Limerick Generating Station, Units 1 and 2
Facility Operating License Nos. NPF-39 and NPF-85
NRC Docket Nos. 50-352 and 50-353

Subject: Third Six-Month Status Report in Response to March 12, 2012 Commission Order
Modifying Licenses with Regard to Requirements for Mitigation Strategies for Beyond-
Design-Basis External Events (Order Number EA-12-049)

**Third Six-Month Status Report for the Implementation of Order EA-12-049, Order
Modifying Licenses with Regard to Requirements for Mitigation Strategies for Beyond-
Design-Basis External Events**

TITLE: Use of MAAP In Support of FLEX Implementation

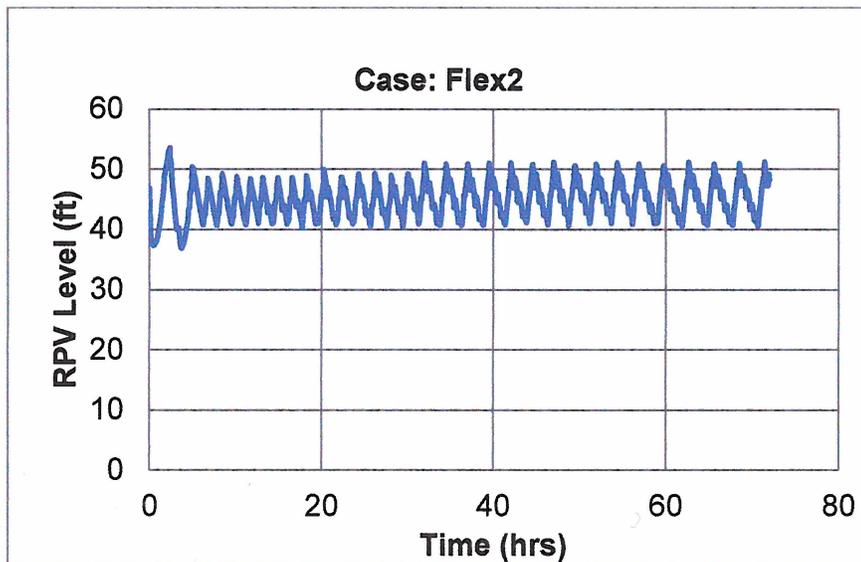
- (2) The collapsed level must remain above Top of Active Fuel (TAF) and the cool down rate must be within technical specification limits.***

Attachment 1A of the Limerick Integrated Plan (Feb 2013) states that the operators would commence a cooldown of the RPV at 20 min per E-1, SBO procedure. A controlled cooldown is identified in the SBO procedures, however, it is authorized to exceed 100 °F/hr if plant conditions require a rapid cooldown. For the MAAP analysis used to simulate the plant response, a single SRV was assumed to be opened to perform the cooldown. The following plot of the RPV pressure from the MAAP analysis confirms this cooldown.

For the representative MAAP run (Case Flex 2), RPV water level remains well above Top of active fuel (TAF) for the duration of the analysis. The plot below shows that the lowest RPV level, calculated by MAAP, was approximately 38 ft above the bottom of the reactor vessel. TAF is located at 30.5 ft for Limerick Units 1 and 2. As shown in the following plot, the collapsed RPV water level remains approximately 8' above TAF.

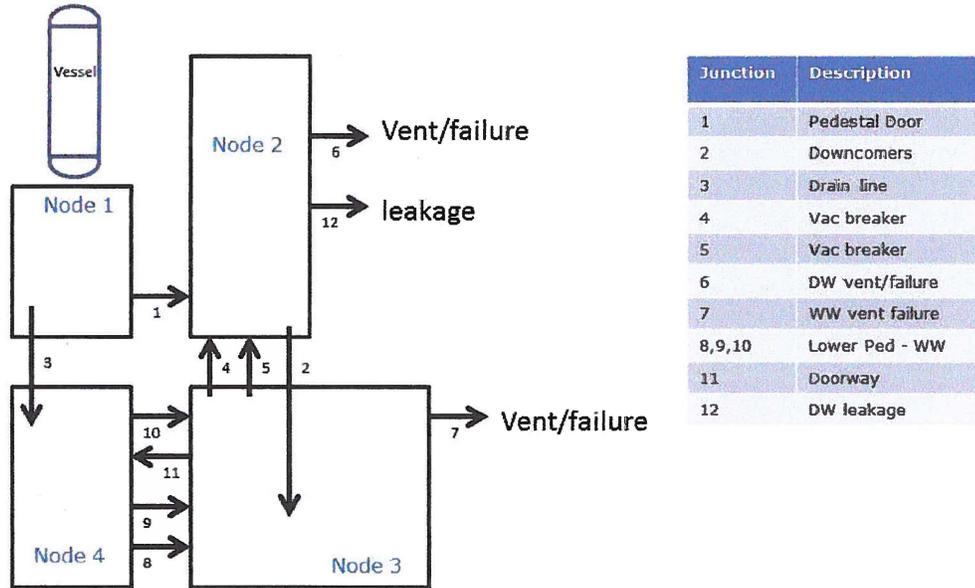
(4) In using MAAP4, the licensee must identify and justify the subset of key modeling parameters cited from Tables 4-1 through 4-6 of the "MAAP4 Application Guidance, Desktop Reference for Using MAAP4 Software, Revision 2" (Electric Power Research Institute Report 1020236). This should include response at a plant-specific level regarding specific coding options and parameter choices for key models that would be expected to substantially affect the ELAP analysis performed for that licensee's plant. Although some suggested key phenomena are identified below, other parameters considered important in the simulation of the ELAP event by the vendor / licensee should also be included.

a. Nodalization

a. The reactor vessel nodalization is fixed by the MAAP code and cannot be altered by the user, with the exception of the detailed core nodalization. The Limerick MAAP 4.0.6 parameter file divides the core region into 7 equal volume

radial regions and 28 axial regions. The axial nodalization represents 25 equal-sized fueled nodes, 1 unfueled node at the top, and 2 unfueled nodes at the bottom. The figure below, taken from the MAAP User's Manual, illustrates the vessel nodalization scheme.

Containment nodalization is defined by the user. The standard nodalization scheme (as recommended in the MAAP4.0.6 sample parameter file) is used in the Limerick MAAP 4.0.6 parameter file and represents the following individual compartments:

1. Reactor pedestal region
2. Drywell
3. Wetwell (main pool)
4. Wetwell (under pedestal)

The figure below illustrates the Limerick MAAP containment nodalization along with an identification of containment flow junctions.
